ADDENDUM NO: 04

PROJECT: BCSC Columbus East High School – C4 Addition

PROJECT NO: 2025022

DATE: 11/14/2025

UTILITY PLAN

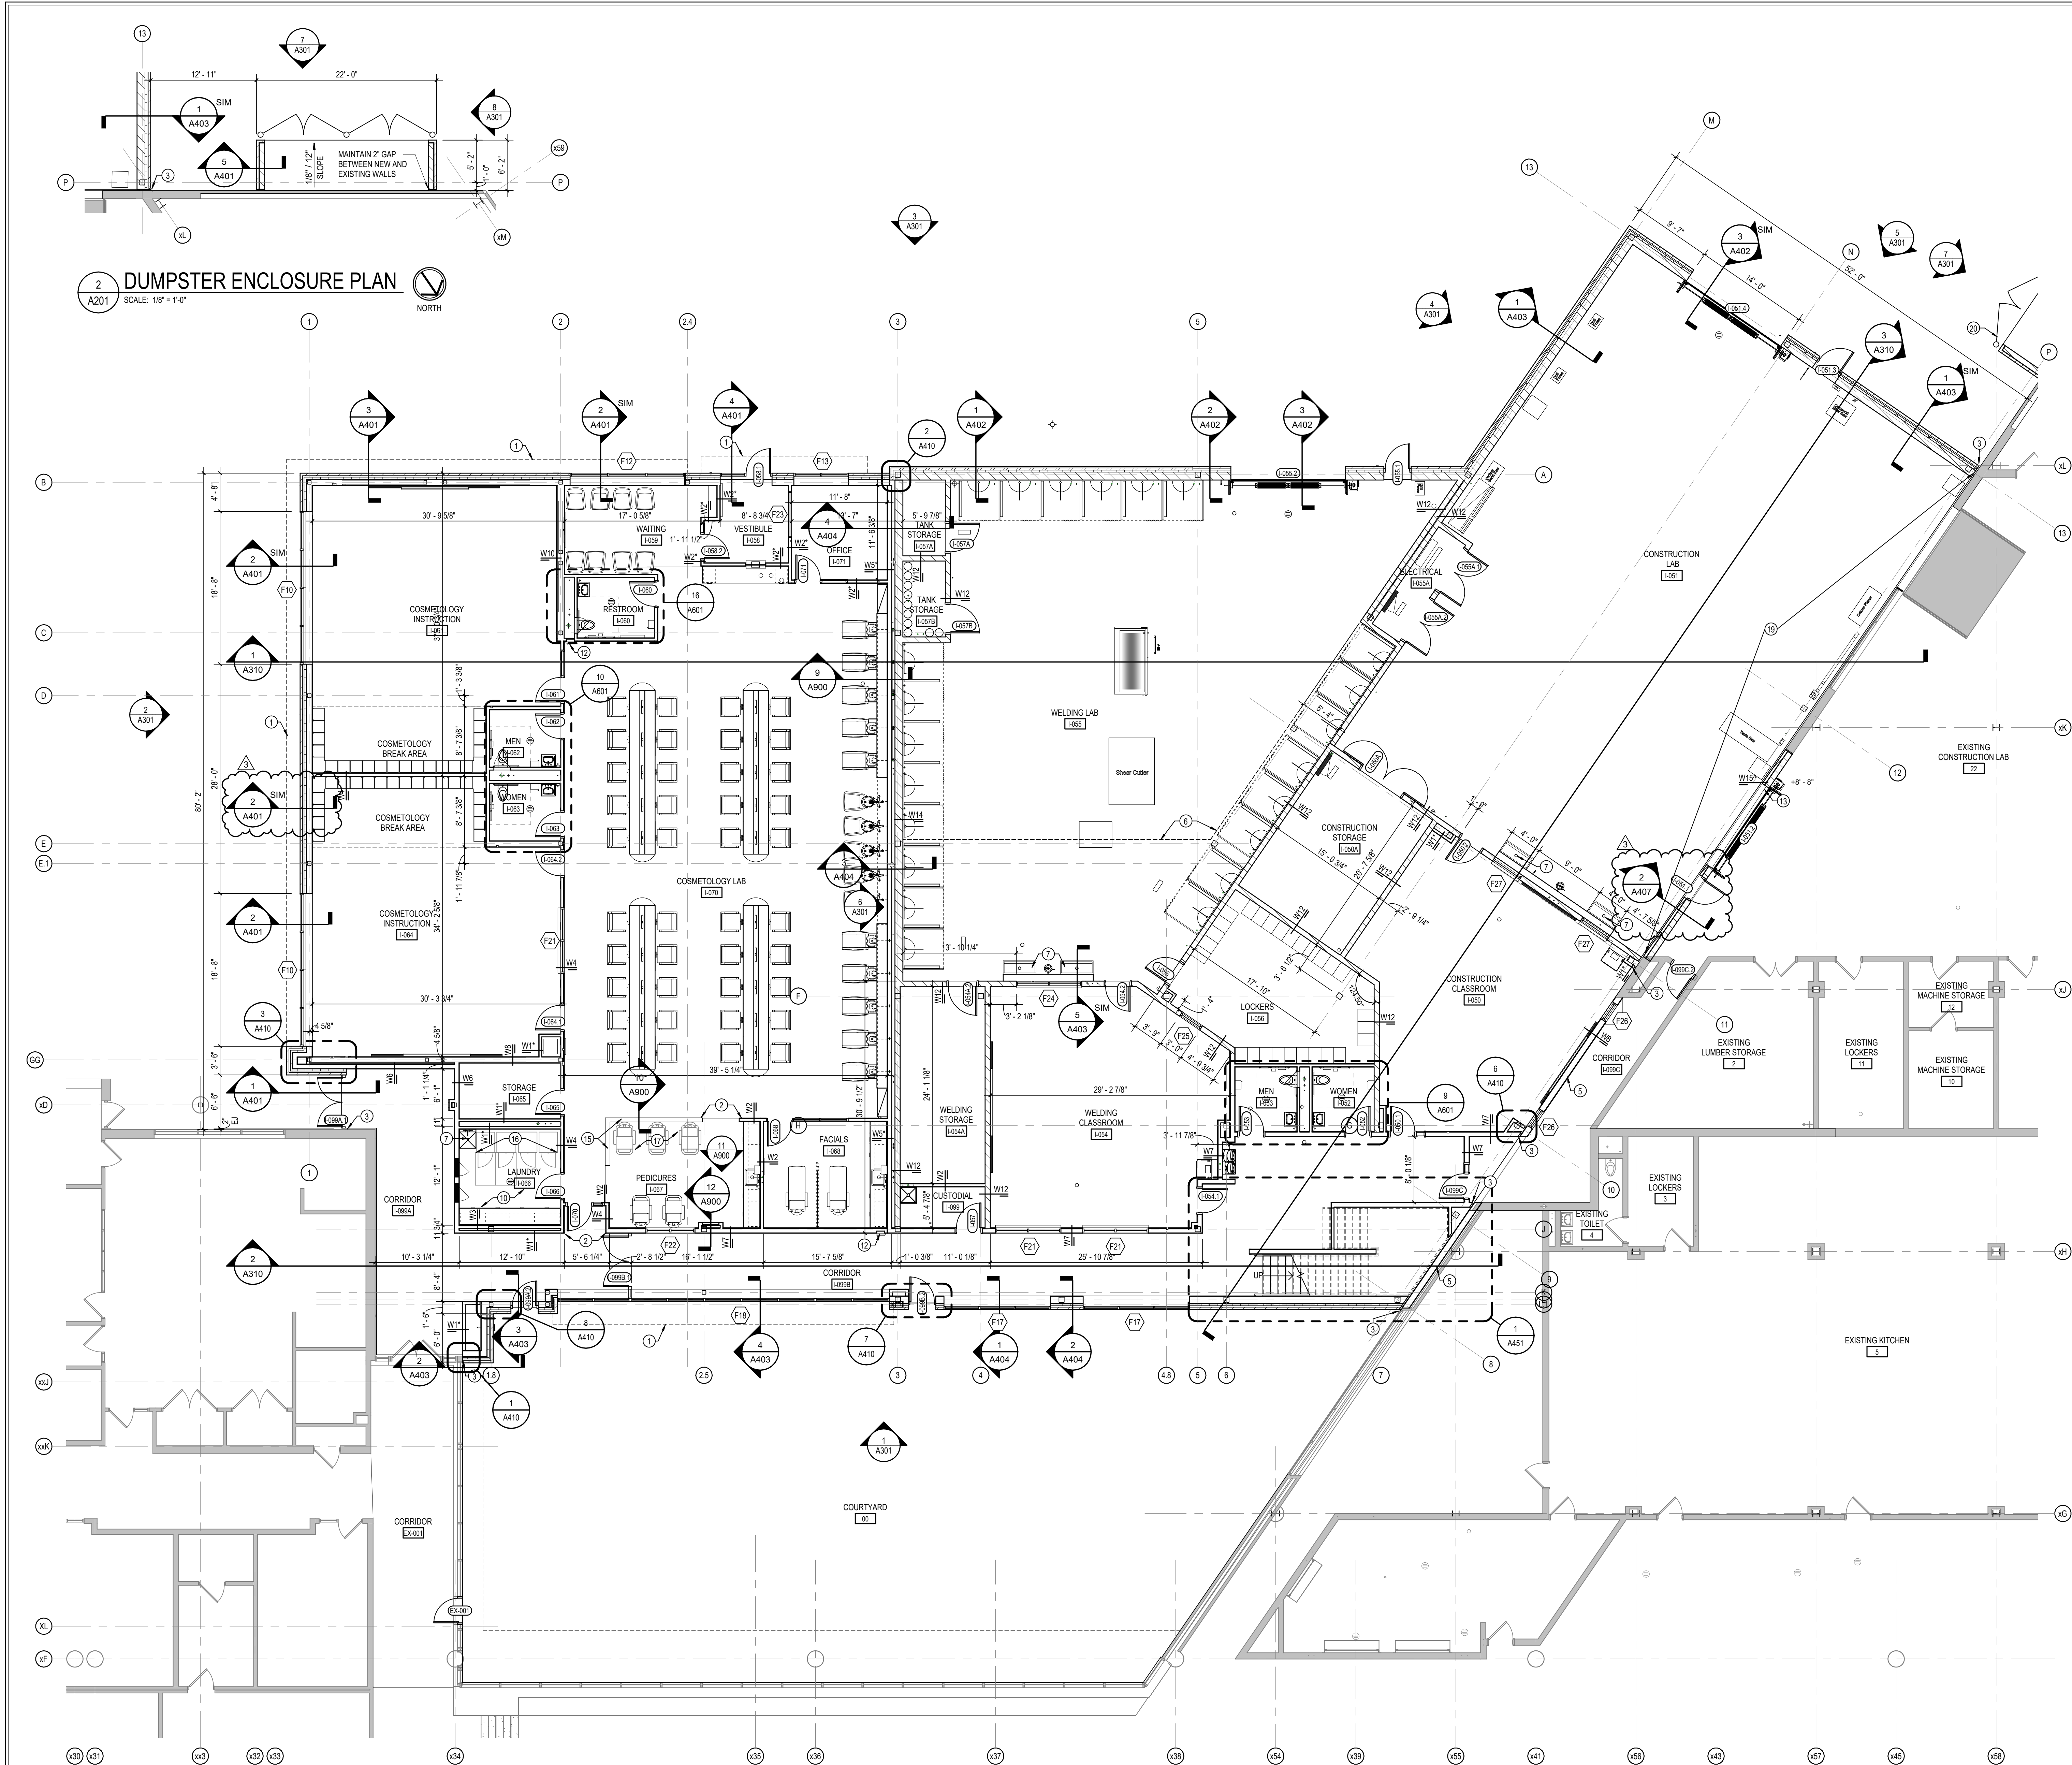
- A. Added a callout to draw attention to the required coordination with the rammed aggregate piers.

1 WALL SECTION
SCALE: 3/4" = 1'-0"

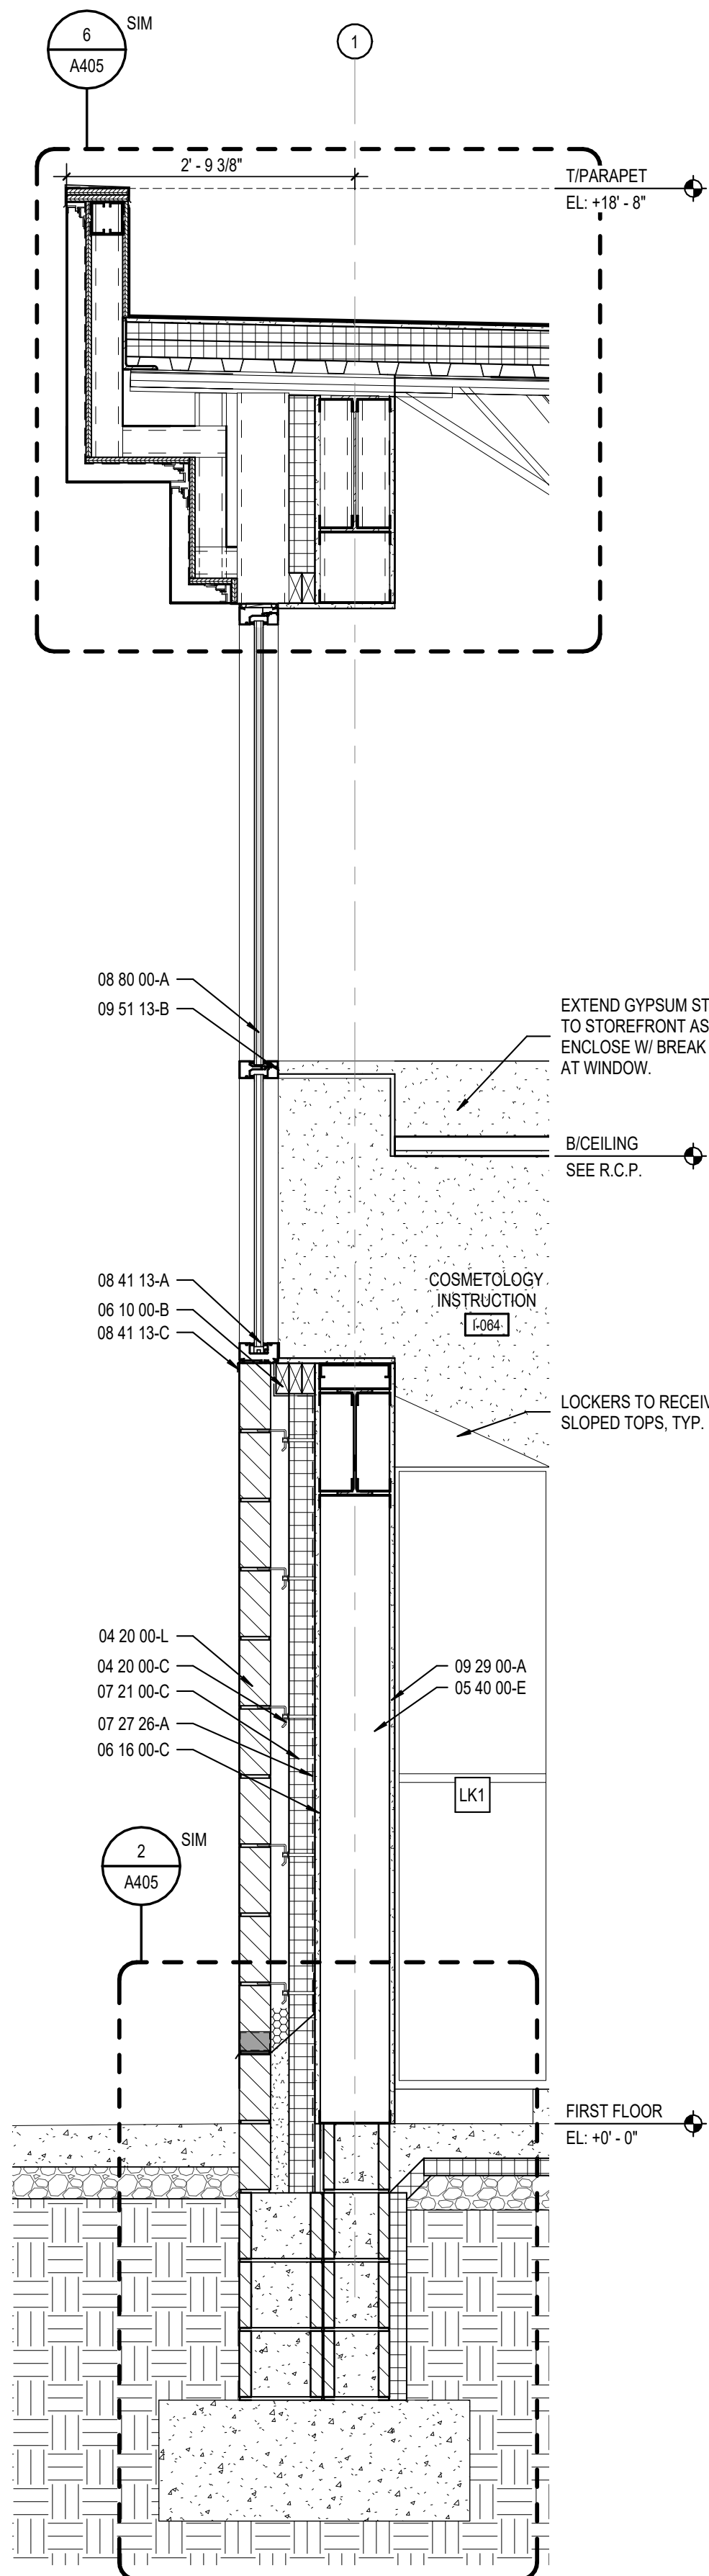
- A. Revise "SIM section cut 3/A401" to be **1/A407** at Cosmetology Break area
